**RiverSmart Schools Installation of Low Impact Development Stormwater Measures and
Outdoor Education Features**

Solicitation No.: DCAM-14-CS-0100

**Amendment No. 3
Issued: March 25, 2013**

Attachment 1

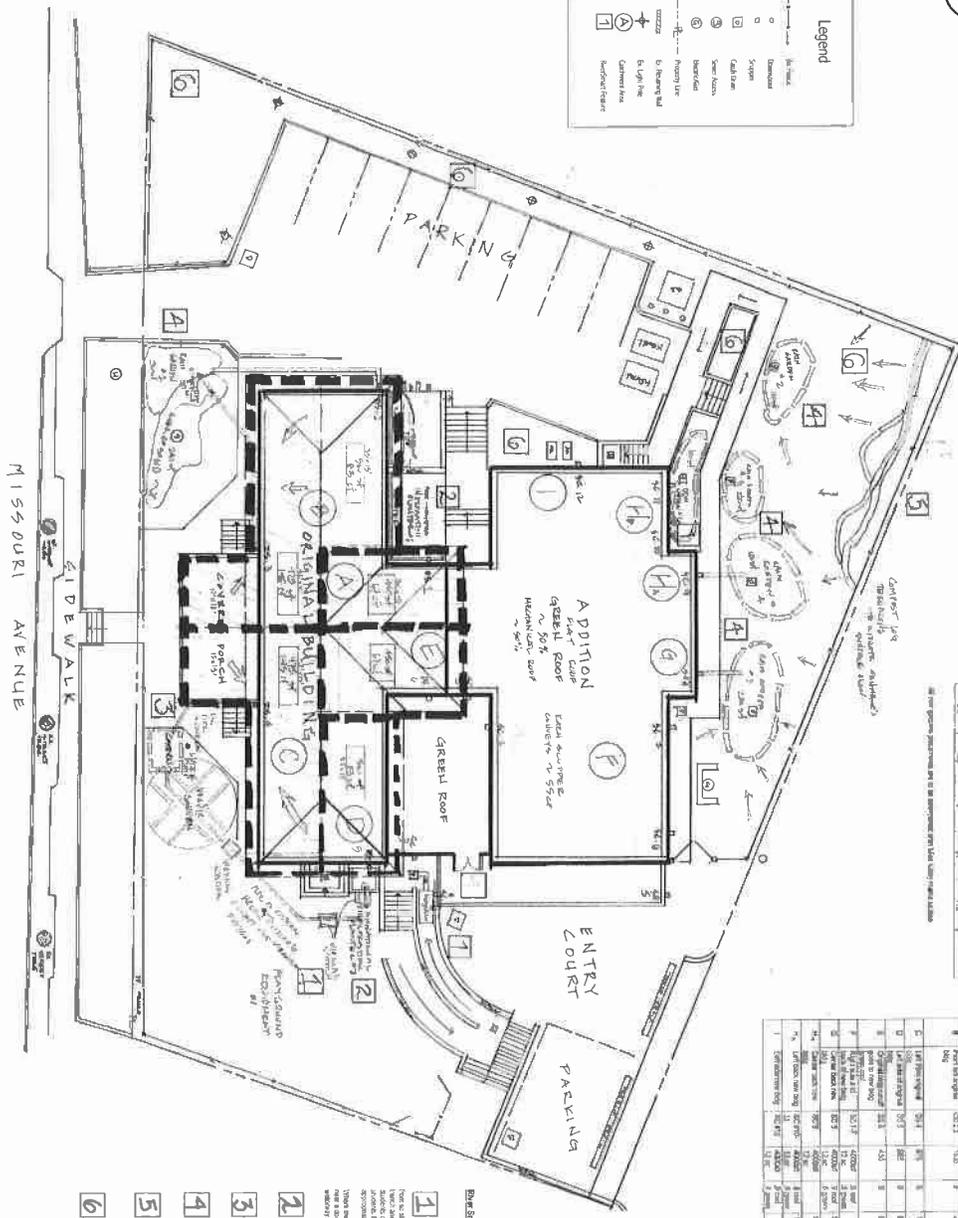
10. If the concept designs are more than references, the two concept designs for LAMB-PCS are conflicting. Please clarify which items, if any, should govern.

11. Has the location of the cisterns been identified at the LAMB-PCS site?

The applicable concept design for the LAMB-PCS is the design provided at the pre-bid and site visit sessions and included as Attachment 1 to this amendment.

Yes, see concept design provided as Attachment 1 to Amendment 3.
